**Staff Analysis of Proposed Amendment to the *Dane County*
Water Quality Plan, Revising the Environmental Corridors of the Central Urban
Service Area in the City of Madison**

1. Applicant: City of Madison

The City of Madison Common Council acted at its January 4, 2006 meeting to request a “major change” to the environmental corridors of the Central Urban Service Area. The change would reduce the 75-foot vegetative wetland buffer on the parcel at 5513 Femrite Drive. The buffer reduction is being proposed to accommodate 15 parking spaces for Badger Coach buses.

Map 1

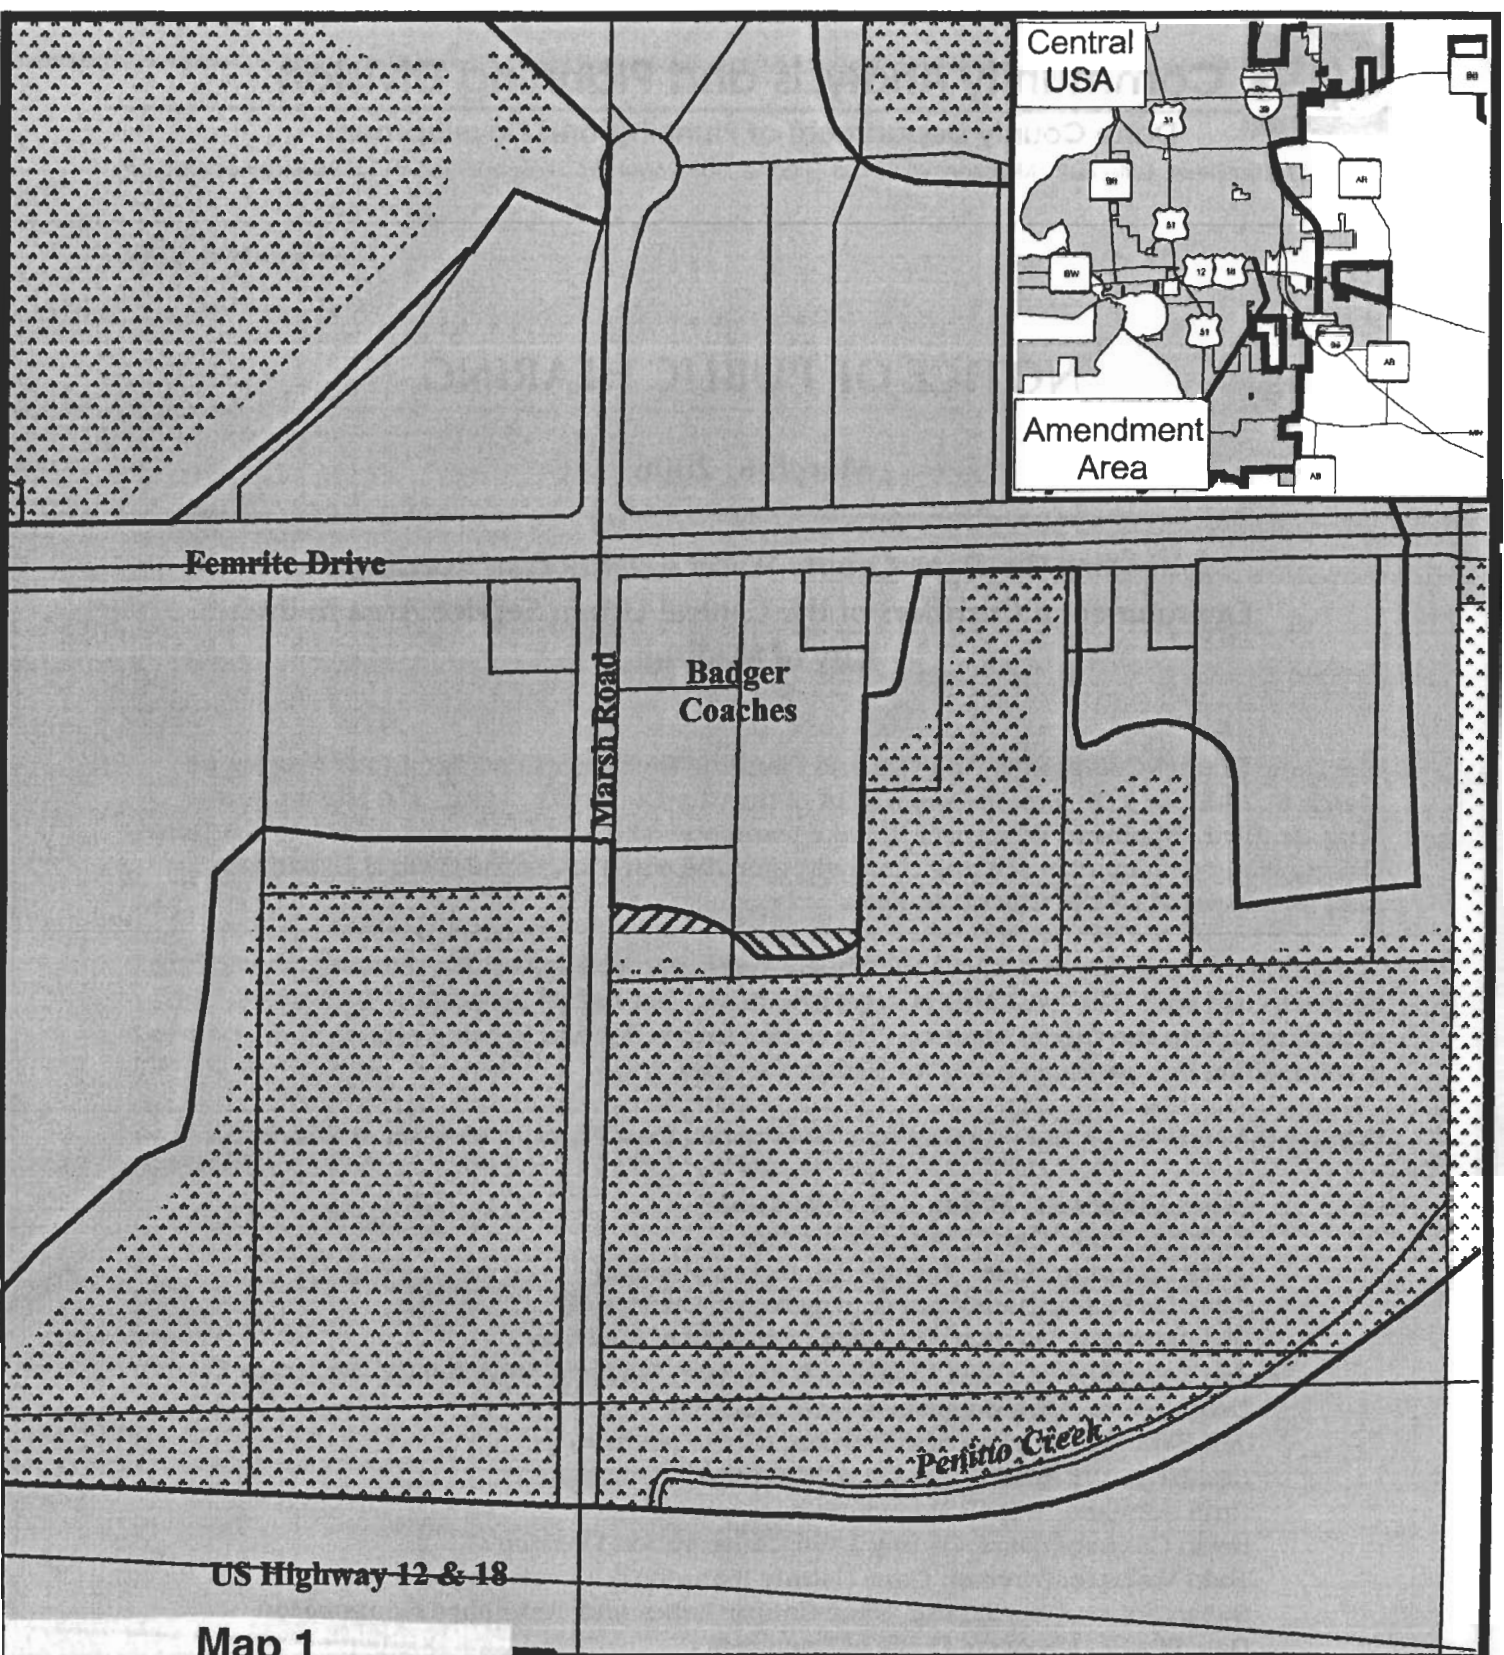
The proposed change reduces the 75-foot vegetative buffer for a small portion of a wetland complex located between Femrite Drive and USH 12/18. The change will remove 0.134 acres of vegetative buffer in one location and will add 0.158 acres to the corridor for mitigation measures (stormwater management). The resulting vegetative buffer width will range from a minimum of 30 feet at the west edge of the property, to a maximum of 110 feet toward the east edge of the parcel (see Map 2).

The mitigation of the adverse impacts of buffer reduction will be through a stormwater management grass swale and a dry detention pond. A dry pond provides insufficient water quality treatment. If the proposed pond is designed as a water quality (wet) pond, it can mitigate the stormwater quality impacts of the proposal. The pond can also be designed to mitigate the water quantity impacts of the increased impervious area. It is also important to contain the stormwater that is generated on the paved areas. To achieve this, it would be advisable to edge the pavement areas with curbs, to prevent the discharge of untreated stormwater to wetland areas.

It should also be remembered that a stormwater facility concentrates the runoff to pond outfalls. This concentrated flow can cause erosion where it is discharged to receiving wetlands and creates channels. It is therefore important to design the discharge structure so it can spread the flow and prevent channelization and the resulting erosion.

In summary, the proposed changes in the area have some positive impacts, and the negative impacts can be mitigated if the stormwater management plan is revised to treat the runoff from paved areas in a water quality (wet) pond, with an outlet designed to prevent the discharge of floatables (oils, grease, and trash) and prevent channelization and erosion in the wetlands at the outfall.

Submit a detailed stormwater quality and quantity management plan for CAPD and DCL&WCD staff review and approval prior to land disturbance in the area of buffer reduction. Stormwater measures should include the following:

1. Provide stormwater quality treatment for polluted stormwater from the entire site.
2. Provide a minimum of 2 feet of effective pool depth.
3. Prevent increased erosion and channelization in adjacent and downstream areas.
4. Prevent floatables from getting flushed out of the pond.
